**ALERT SERVICE BULLETIN**  
REVISION NOTICE

**SUBJECT: REVISION A TO ALERT SERVICE BULLETIN 407-10-93:  
TAILBOOM ATTACHMENT HARDWARE, REPLACEMENT OF.**

NO. 407-10-93

**SUBJECT:** TAILBOOM ATTACHMENT HARDWARE,  
REPLACEMENT OF.

FIGURE 2: Replacement of tailboom upper attachment bolts (Sheet 1 of 2)

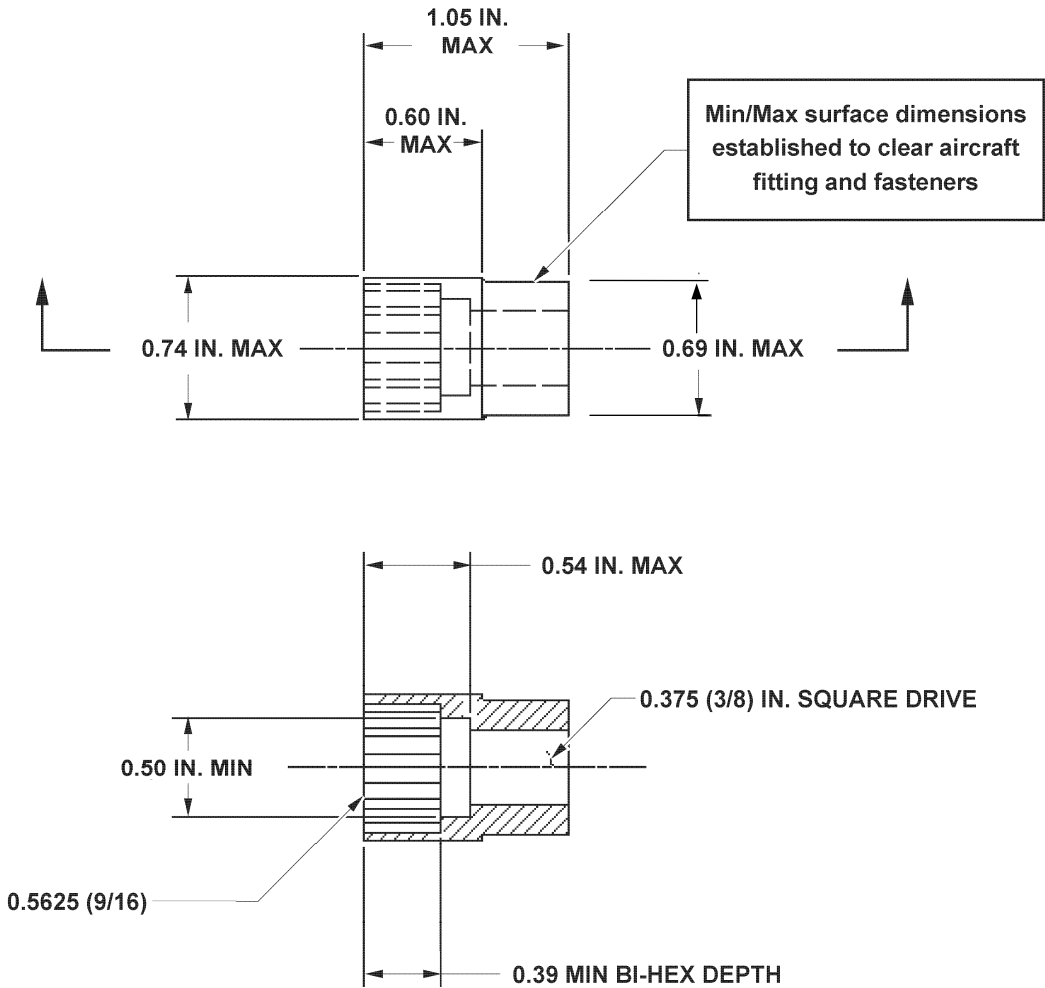
Bell Helicopter has reviewed the tailboom attachment installation of the Model 407. It has been determined that the torque values specified in the maintenance manual and used during assembly of the 407 for the tailboom attachment bolts exceed the specified torque range recommended for subject bolts.

This bulletin mandates the removal of the existing tailboom attachment hardware and the installation of new hardware with reduced torque values. In addition, specific hardware installation/torquing procedure is provided for the tailboom to aft fuselage joint.

1. (Ref. Figure 2) Remove left upper attachment bolt (1) and nut (2) but retain the chamfered washer (4) and the regular washers (3). Discard the nut (2) and the bolt (1) you have removed.

5. (Ref. Figure 2) Remove left lower attachment bolt (10) and nut (7) but retain the chamfered washers (8) and the regular washers (9). Discard the nut (7) and the bolt (10) you have removed.

For torque check purposes, the assembly torque to be applied is the minimum specified torque (see Figure 2) plus the minimum acceptable tare torque of 14 inch/lbs(1.58 Nm) for the upper nuts (2) and 9.5 inch/Lbs (1.07Nm) for the lower nuts(7).

360 TO 370 INCH/LBS  
(40.6 TO 41.8 Nm)

570 TO 580 INCH/LBS  
(64.4 TO 65.5 Nm)

FIGURE 1: Maximum and minimum reference dimensions of socket

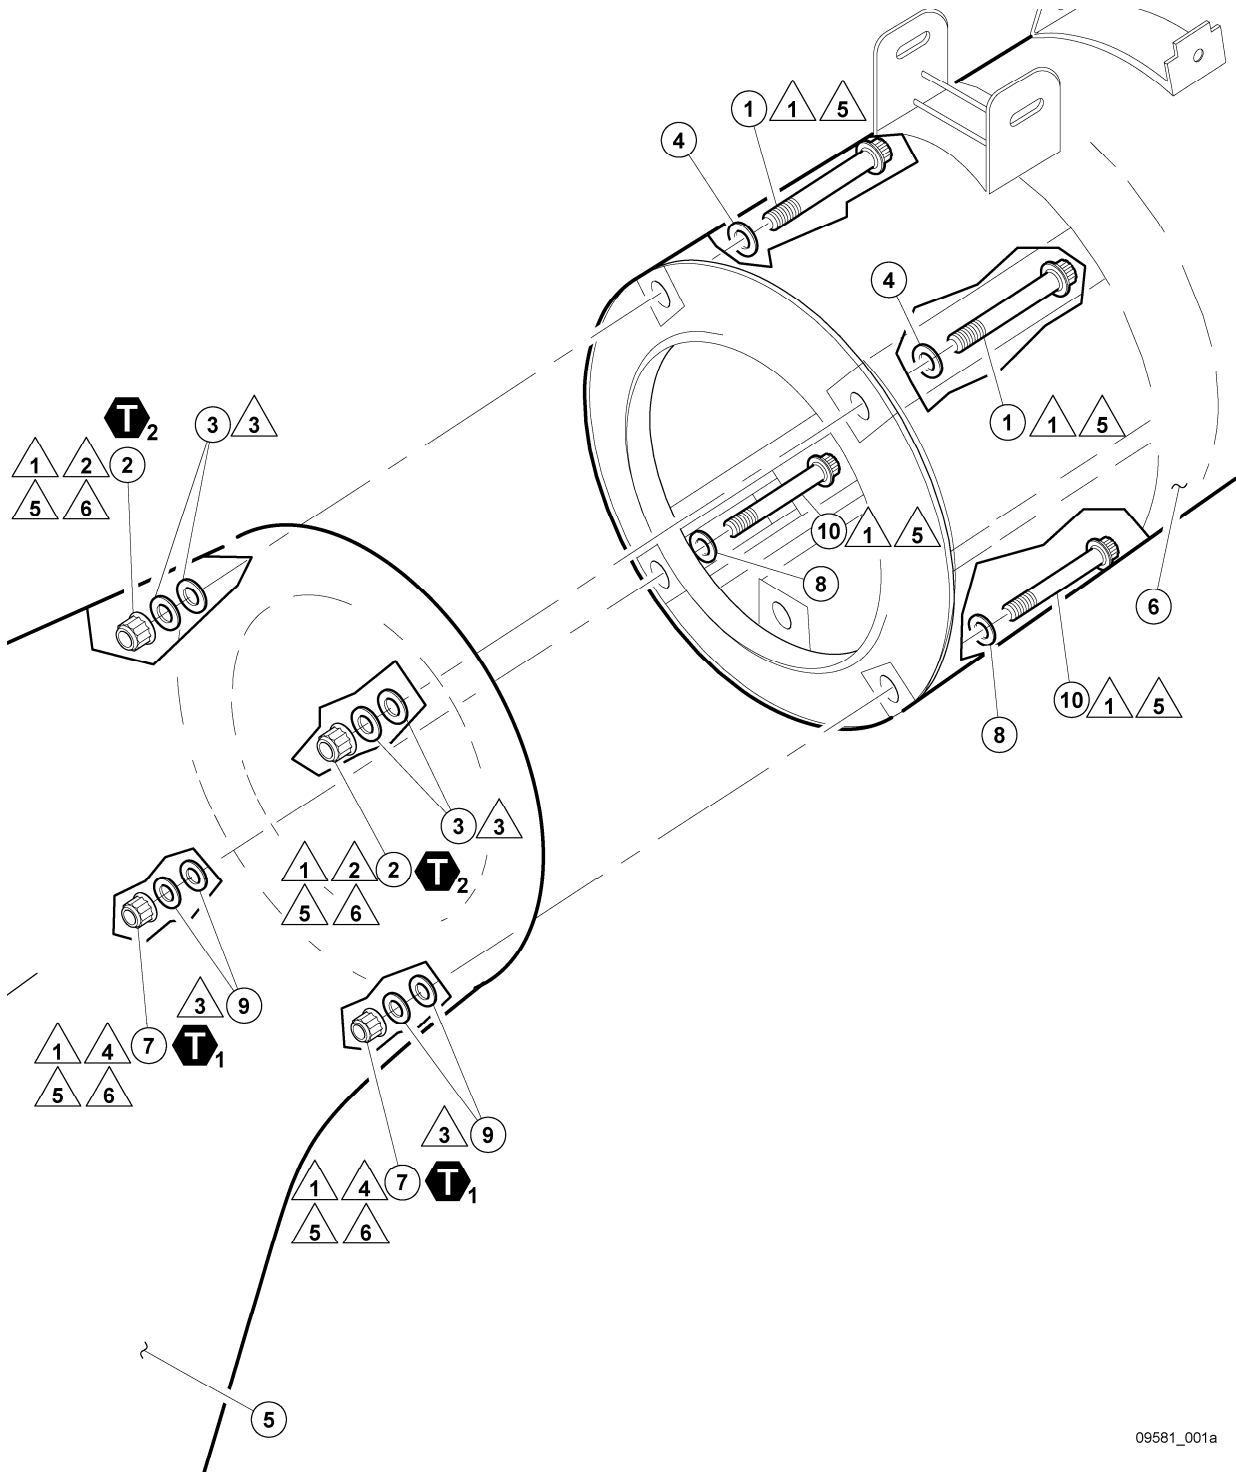
Revision A to this bulletin removes the statement implying that one socket was delivered with every new ship from factory. This tool was never part of the aircraft's loose equipments list at delivery. Also, tool P/N 407-230-001-101 dimensions have been included to assist operators in locally fabricating their own if necessary.

**Note: an equivalent tool may be locally fabricated using a commercial 12-point socket. Refer to Figure 1.**
